PARTIAL LEVEL-08 NEW STEEL COLUMN ADHESIVE ANCHOR PLAN-(PHASE-1) (SEQ#-1)

STEEL FAB ENTERPRISES, LLC
MISCELLANEOUS METALS FABRICATOR AND ERECTORS
623 BAUMGARDNER ROAD, LANCASTER, PA 17603
TEL. (717)464-0330 FAX (717)464-9464
WWW.STEELFABENTERPRISES.COM

PROJECT OWNER : 1250 MARYLAND AVENUE
PROJECT DESCRIPTION : 1250 MARYLAND AVENUE
PROJECT ADDRESS : 12
CONTRACTOR : BALFO
DRAWN BY : JSV
CHECKED BY : MNK
DWG DESCRIPTION : PA ANCHOR PLAN-(PHASE-1)(SEQ#2)

1 / 02AB01

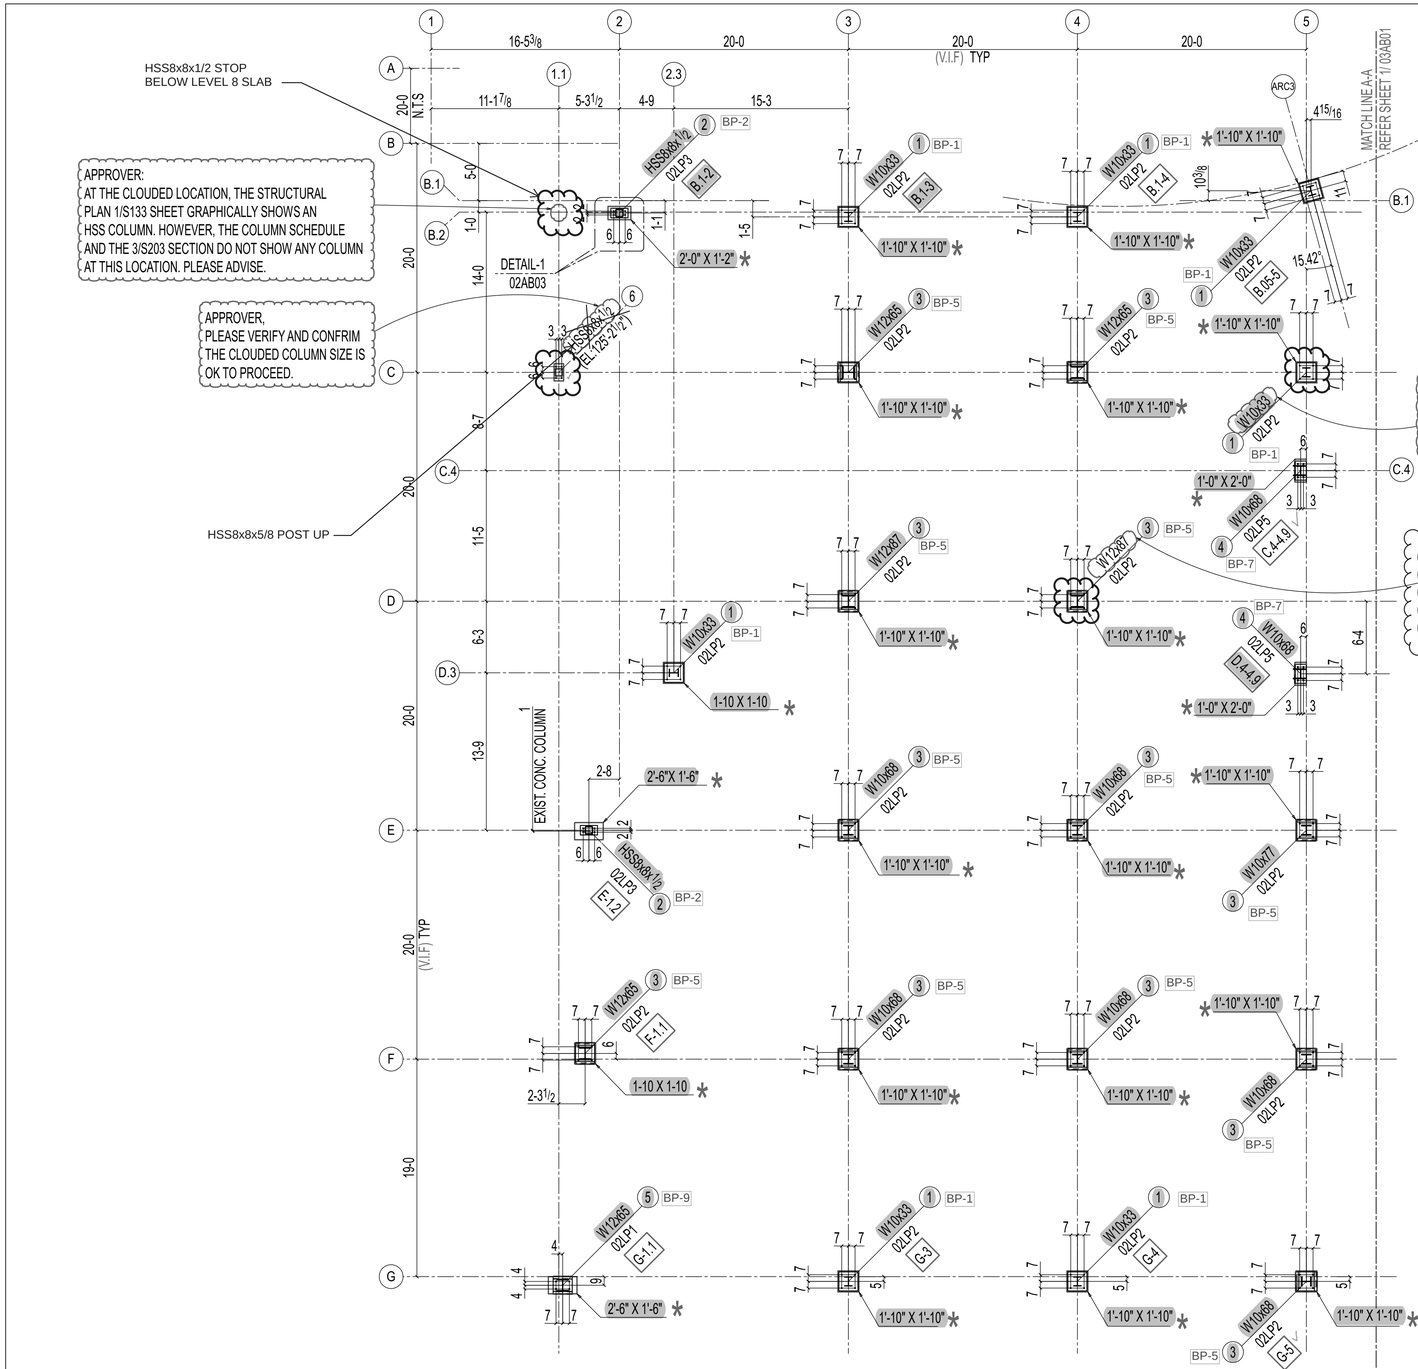
APPROVER, PLEASE VERIFY AND CONFIRM CLOUDED EXISTING LEVEL-08 SLAB ELEVATION.

PLEASE CENTER ALL NEW STEEL COLUMN WITH CENTER OF EXISTING CONCRETE COLUMN.

FOR LOCATIONS WHERE CENTERINING IS NOT POSSIBLE, PROVIDE DETAIL LOCATION INFORMATION FOR REVIEW

APPROVER, PLEASE REVIEW AND VERIFY ALL EXISTING COLUMN SIZES ARE OK TO PROCEED?

APPROVER; THE STRUCTURAL DRWAINGS DO NOT SHOW CONTINUOUS GRID DIMENSIONS FOR THE ARC GRID AND SKEWED GRID.WE HAVE FOLLOWED THE DIMENSIONS AS PER THE ARCHITECTURAL SHEET A002.PLEASE CONFIRM.

APPROVER, PLEASE CONFIRM,WE ASSUMED ALL NEW COLUMNS SHOULD BE PLACED AT CENTER OF EXISTING CONCRETE COLUMN. HOWEVER WE HAVE RECEIVED FIELD MEASUREMENT FOR THE CENTER OF EXISTING COLUMN.

AFTER INCORPORTAING THE ALL FIELD MEASUREMENT, WE HAVE PLACE MOST OF THE NEW COLUMNS AT CENTER OF EXISTING CONCRETE COLUMNS.

ADDITIONALLY,WE HAVE OFFSETTED THE SOME COLUMN FROM CENTER OF EXISTING CONCRETE COLUMN SINCE STRUCTURAL DRAWING GRAPHICALLY SHOWNS THE NEW COLUMN FROM EX.CONCRETE COLUMN CENTER PLEASE ADVISE TYPICAL FOR THIS PROJECT.

Arch, Please review clouded notes and advise.

SLAB ELEVATION IS AN EXISTING CONDITION THAT SHOULD BE VERIFIED IN FIELD.

ALL COLUMNS TO BE CENTERED ON EXG COLUMNS UNLESS NOTED OTHERWISE.

RESPONSIBILITY OF CONTRACTOR AND GC TO VERIFY ALL EXISTING CONDITIONS, REVIEWED TO CONFIRM WITH DESIGN DRAWINGS ONLY

EXISTING COLUMN SIZES CONFIRMED WITH EXISTING STRUCTURAL DRAWINGS. VERIFY IN FIELD FOR ACTUAL COLUMN SIZE

SEE NOTE 8 ON S133 "ALL GRID DIMENSIONS TO BE VERIFIED IN FIELD"

ARCH. PLEASE COMMENTS

JB- Reviewed for Compliance
